# **Establishment Inspection Report**

Zhejiang Huahai Pharmaceutical Co., Ltd.

#### **SUMMARY**

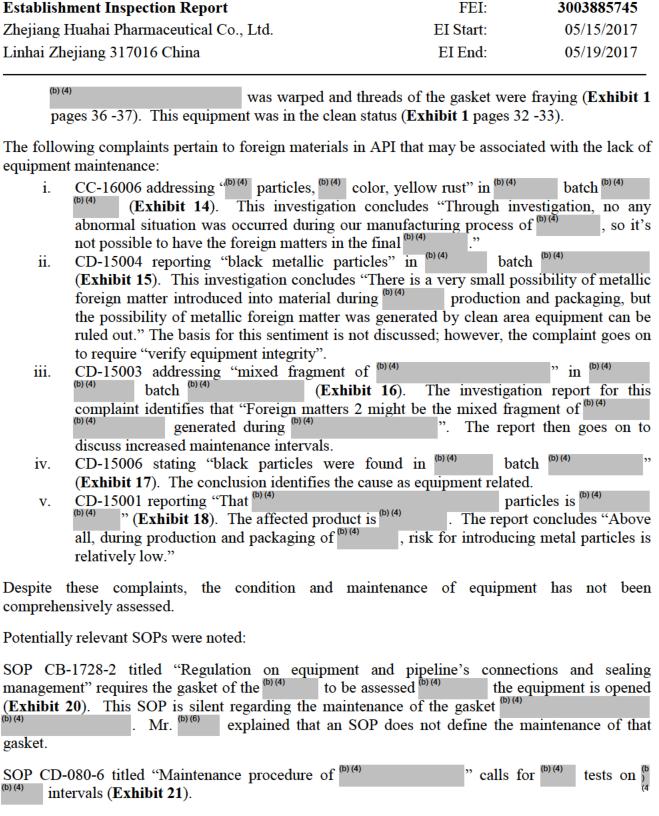
a)	On May 15, 2017, V-305 exhibited particulate matter and paint on
	the inner face of the gasket to the (b) (4)  ). Further, this gasket was fraying, and loose threads were visible (b) (4)  The gasket inside the (b) (4)  had
	deteriorated such that the missing portions could not be accounted for. The mass balance of
	this gasket could not be accounted for. Further, this gasket was discolored brown. Finally, a
	portion of the interior of this (b) (4) was discolored white. This (b) (4) was
	utilized in the manufacture of (b) (4) lot (b) (4) intended for the US
	market. This equipment was in the clean status.

b)	On May 15, 2017, the (b) (4) to (b) (4) J09-805 contained screws displaying a reddish-brown discoloration consistent with rust (interior of the (b) (4) ). This (b) (4) was utilized in the manufacture of (b) (4) lot (b) (4) intended for the US market. This equipment was in the clean status and is used in the (b) (4)

c)	On May 15, 2017, (b) (4) IX-501-2 exhibited particulate matter and (b) (4) paint on the inner face of the gasket to the (b) (4) (b) (4) Particulate matter and paint were falling from the (b) (4) upon opening the (b) (4) Further, this gasket was fraying, and loose threads were visible (b) (4)
	. The gasket inside the (b) (4) had
	deteriorated such that the missing portions could not be accounted for. The mass balance of this gasket could not be accounted for. Further, this gasket was discolored brown. Finally, the interior of this balance of this b

During closeout, Mr. Jun Du explained that these issues are associated with the age of the equipment. He called my attention to the firm refurbishing Building bedocumented in change request Q/ZHHJG 163-4 effective December 10, 2015. Mr. bad explained this change control as requiring the facilities to be updated due to production demands and equipment / facility age. I noted that the firm continues API manufacture without a comprehensive facility assessment and has consumer complaints potentially stemming from the equipment condition.

Additionally, Mr. Jun Du provided a draft document (**Exhibit 22**) acknowledging the aforementioned Observation and proposing corrective action.
